Joint Meeting of the RID Committee of Experts and the Working Party on the Transport of Dangerous Goods

Marking of tanks carrying flammable liquefied gases that are fitted with safety valves

Transmitted by Liquid Gas Europe on behalf of the BLEVE working group

Amended text for ECE/TRANS/WP.15/AC.1/2022/12

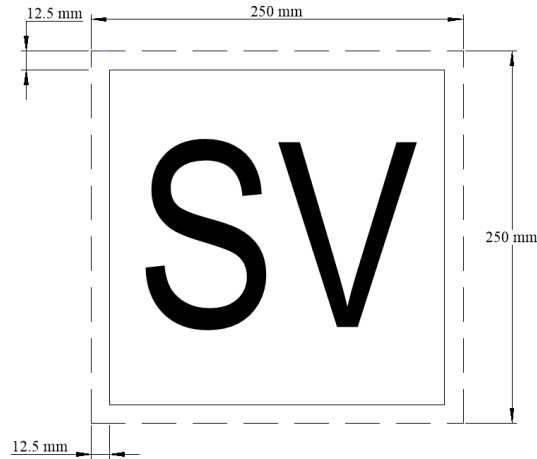
6.8.3.2.9.6.23 The mark shall consist of a white square with minimum dimensions of 250 mm x 250 mm. The ~~black~~ line inside the edge shall be **black**, parallel and **approximately** 12.5 mm from the outside of that line to the outside edge of the mark. The ~~black~~ letters ‘SV’ shall be **black**, a minimum of 120 mm high **and have a minimum stroke thickness of 12 mm.**

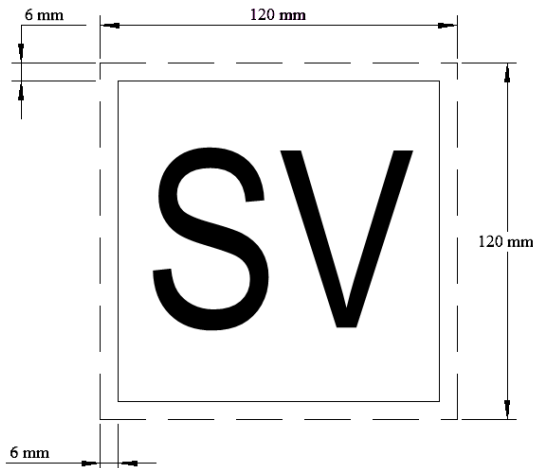
6.8.3.2.9.6.34 For tank containers with a capacity of less than 1 500 litres **the marks may be reduced in dimensions size to not less than 120 mm x 120 mm. The black line inside the edge shall be black, parallel and approximately 6 mm from the outside of that line to the outside edge of the mark. The black letters ‘SV’ shall be black, a minimum of 60 mm high and have a minimum stroke thickness of 6 mm.**
